Service Bulletin

PRELIMINARY INFORMATION

Subject: Front Seat Lateral Movement and/or Unable To Install Front Seat Lateral Retainer When Performing PI1376 Or PI1183

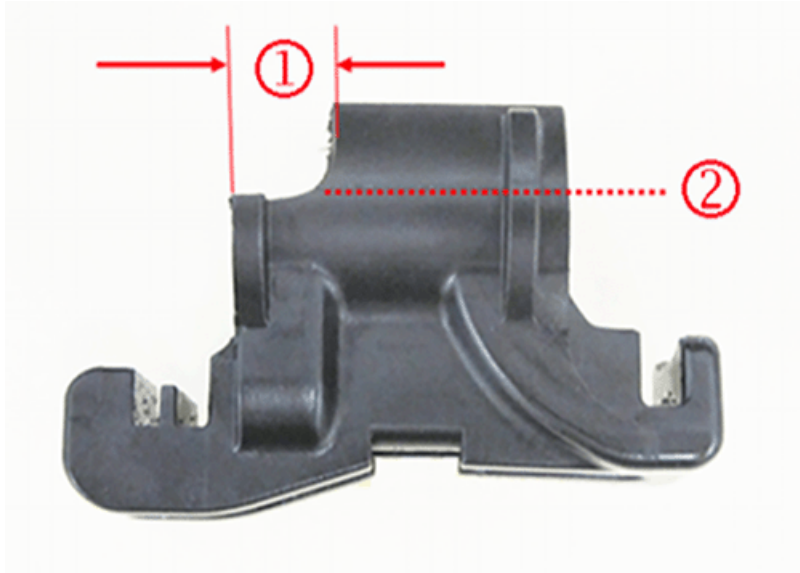
Important: In order to be able to correctly install the front seat lateral retainer on the new updated seat frame design, a modification **MUST** be done, as shown below.

1. It will be necessary to remove plastic material from the top side of the guide end of the lateral retainer to enable installation. Using a grinder, or similar tool, remove approximately 10 mm (0.40 in) of material (1) from the top, down to the mold seam line (2), shown below.
